SAFETY RECALL

Volvo Trucks North America

Date	Number	Release	Page
06.2025	RVXX2505	01	1 (11)

Improper Power Cable Routing VN

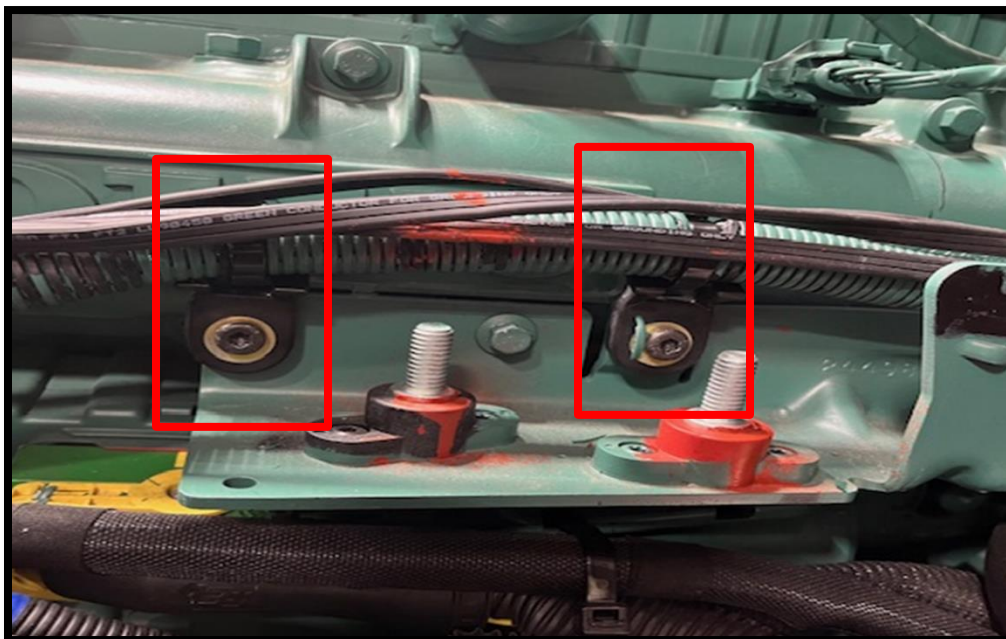
Certain Volvo Heavy Duty vehicles may have been built with a specific arrangement of power cables where the 12-volt positive can encounter the 48-volt negative terminal and potentially cause chaffing and or then short.

If the battery cables rub on the terminal there is the risk of an electrical short which may disable power to the engine or create the risk of fire.

15. Install the Zip-Tie saddle (P/N 21400204), M6 Flange Screw (P/N 984726), and Flange Nut (P/N 990949) in the locations pictured below.
16. Install Zip-Ties (P/N 980464) and secure the cables and wiring that run above the power and ground terminals.

Ensure all cables and wiring above the terminals are secure and that no contact with the terminals is possible.

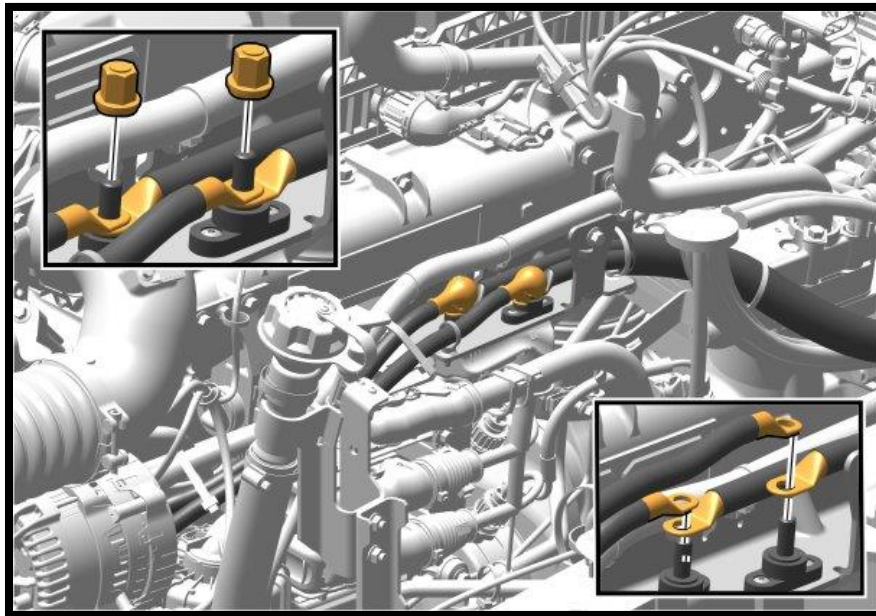
When torquing the cables, ensure they do not twist or rotate into each other, as this may cause contact with the opposing terminal. Verify that there is adequate spacing between the cables and opposing terminals to prevent accidental contact or electrical faults.

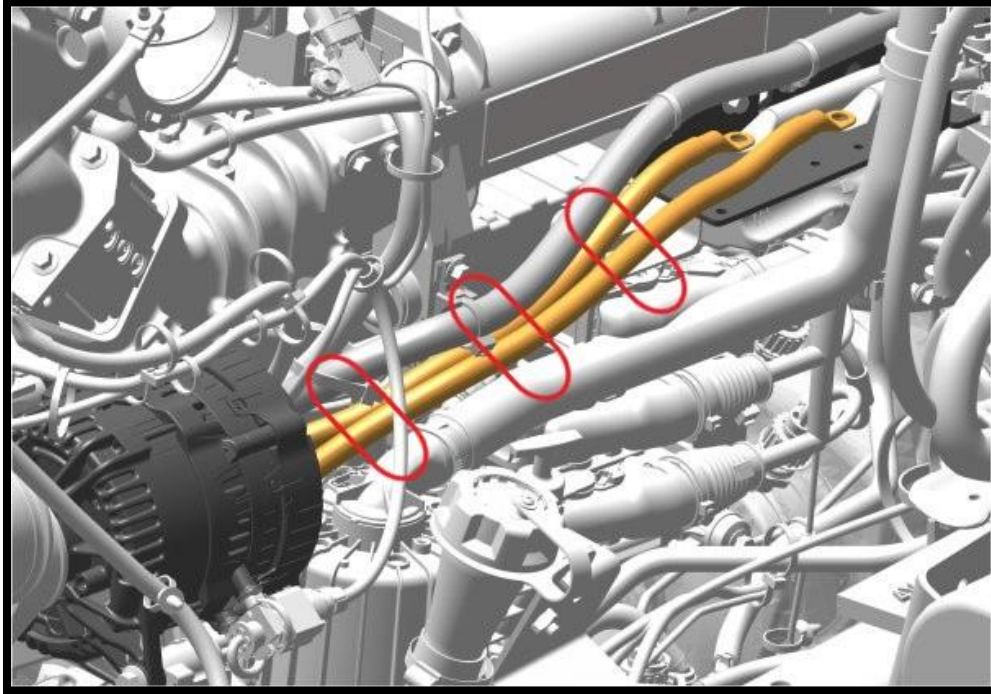
21. Install double headed zip ties (P/N-20395795) in the locations pictured below.

Ensure there is sufficient spacing between opposing cables, that all cables are securely fastened, and that they do not come into contact with any components that could cause damage to the cables.
